SUBMITTAL SUMMARY REPORT

WaiverSTA-000146-2025

PLAN NAME:	DURIEZ SWIMMING POOL MITIGATION BASIN	LOCATION:	18265 NW HWY 335 WILLISTON,
APPLICATION DATE:	12/16/2025	PARCEL:	01472-000-00
DESCRIPTION:	MITIGATION BASIN FOR SWIMMING POOL PERMIT #BLDR-25-11-00619

Mitigation Basin (DRA):

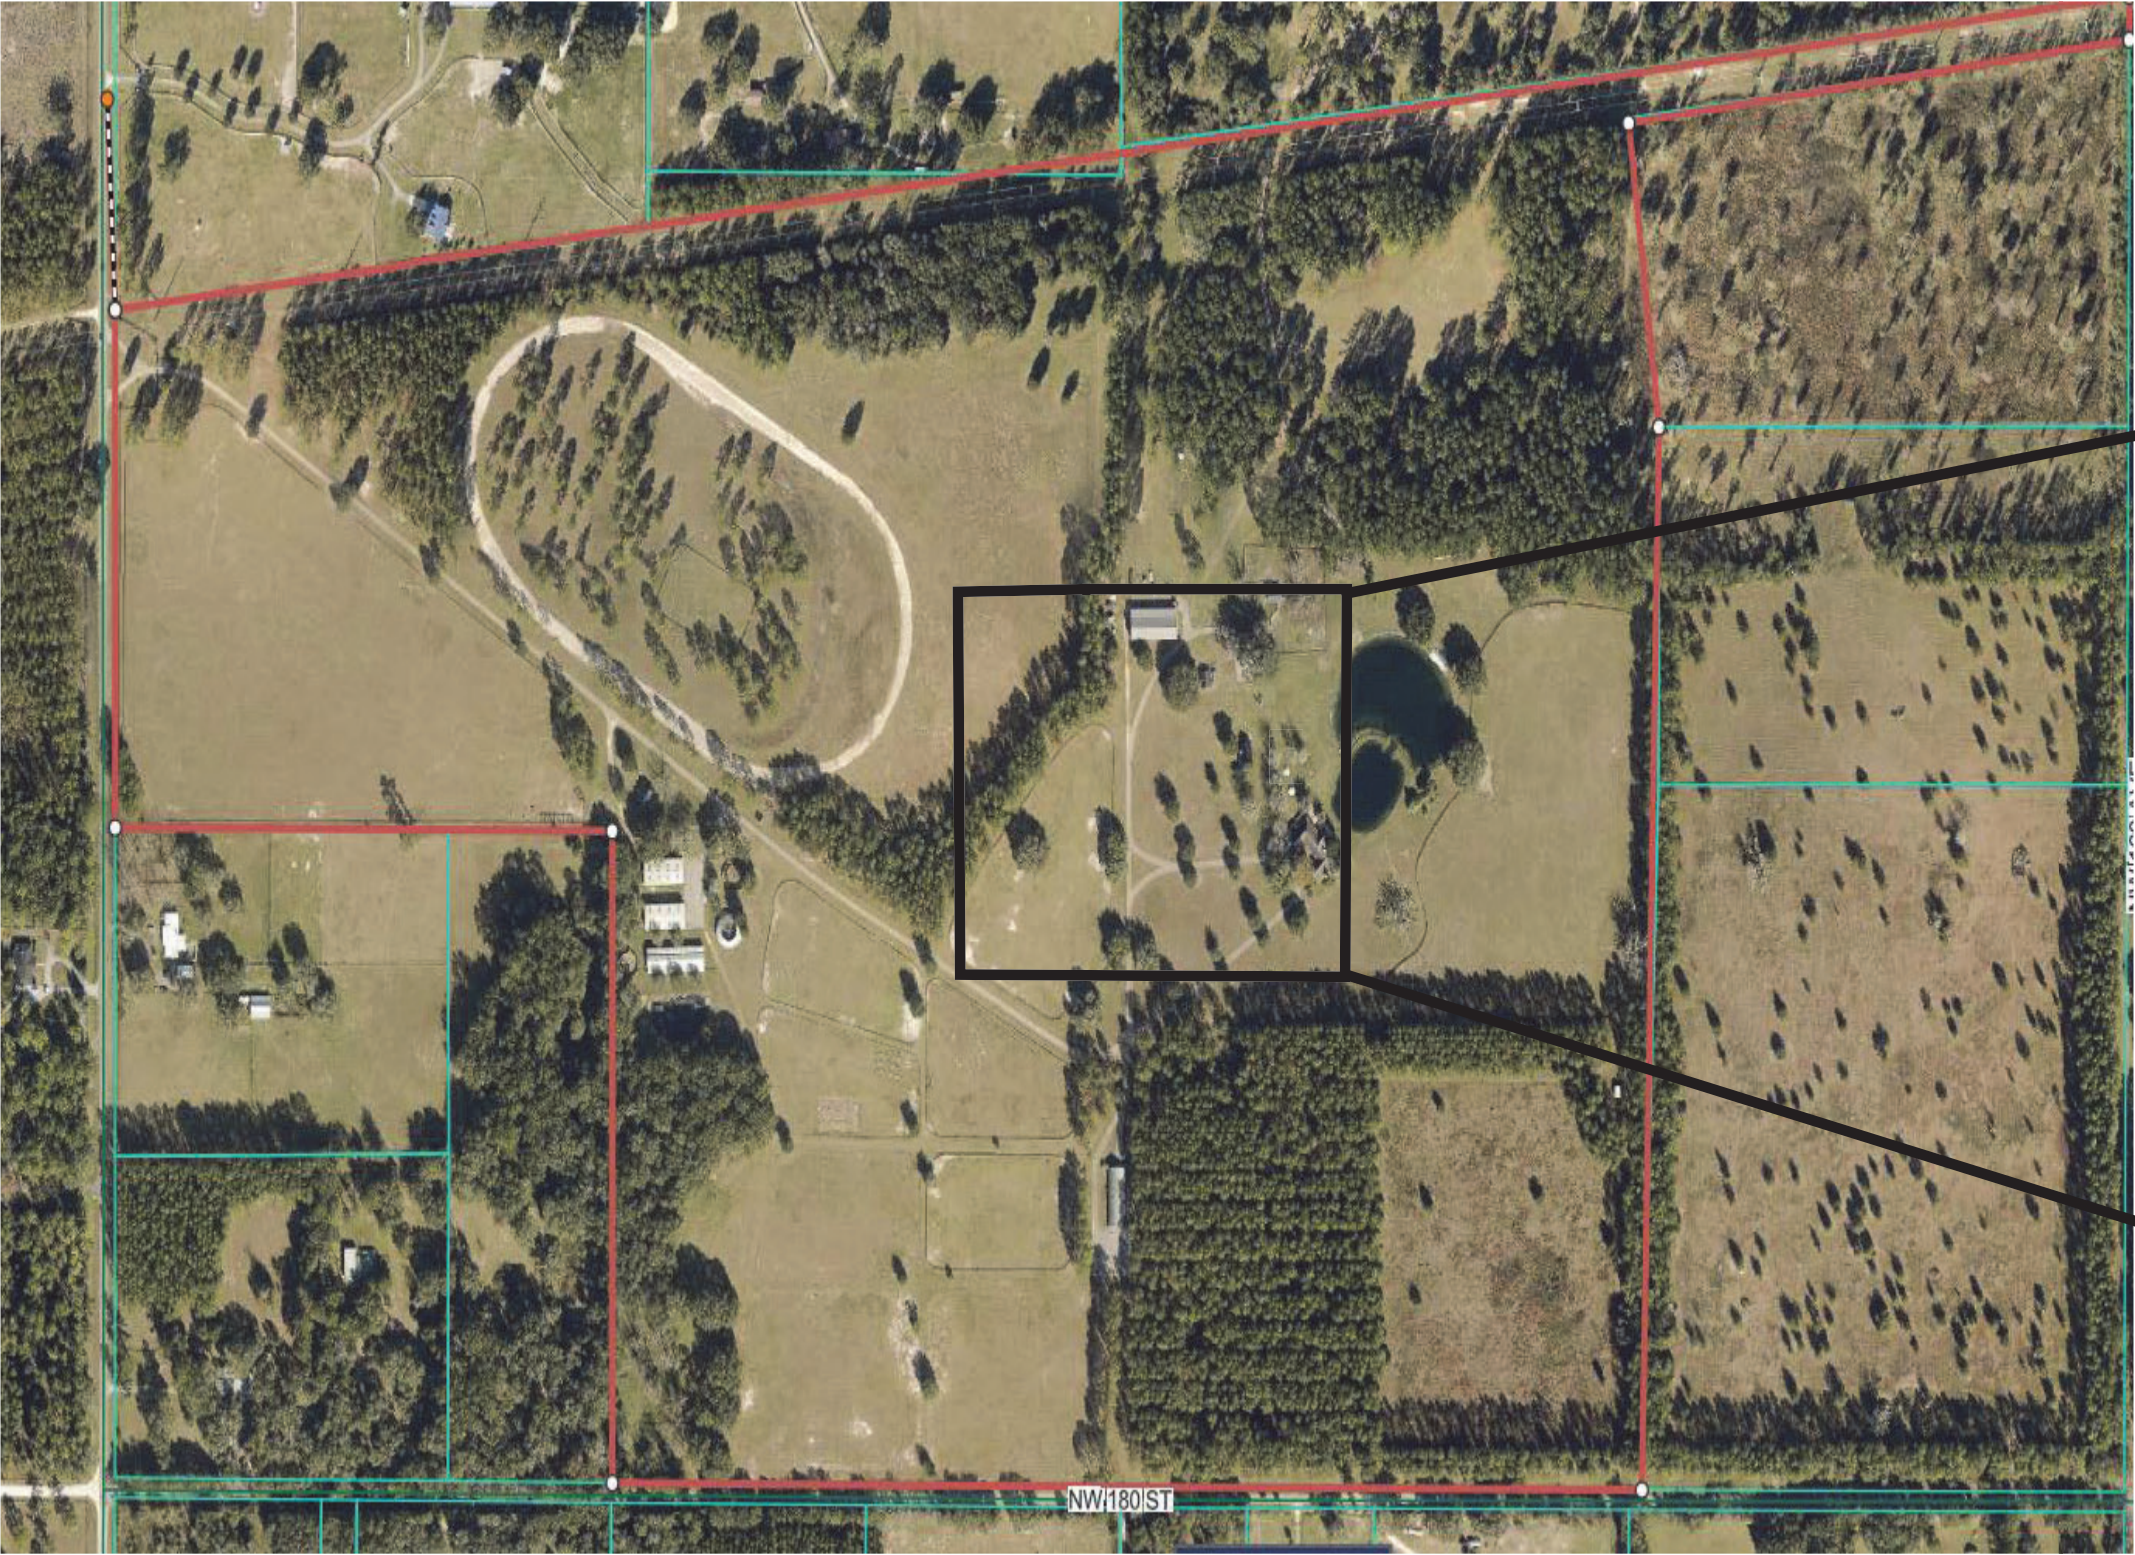
OCE: Waiver Request to Major Site Plan v.1				
ITEM REVIEW NAME (DEPARTMENT)	ASSIGNED TO	DUE	COMPLETE	STATUS
Fire Marshal (Plans) (Fire)		01/16/2026	01/07/2026	Approved
Growth Services Planning & Zoning (DR) (GS Planning and Zoning)	Kathleen Brugnoli	01/16/2026	01/07/2026	Approved
Comments	Defer to Stormwater			
OCE Stormwater (Permits & Plans) (Office of the County Engineer)	Alexander Turnipseed	01/16/2026	01/07/2026	Informational
Comments	The applicant owns a 203.07 -acre parcel (01472-000-00) and according to the MCPA, there is approximately 96,387 sf existing impervious area on-site. The applicant is proposing to add 792 sf for a pool+deck. The total existing and proposed impervious area is 97,179 sf. The site will be approximately 67,179 sf over the allowed 30,000 sf per the Marion County LDC, although only the runoff from 1,012 sf of the overage needs to be addressed per ordinance 25-38. There are several Flood Prone Areas on the property. The proposed addition as well as much of the existing impervious area drains towards a flood prone area that is contained to the site that has sufficient storage for the impervious area overage.
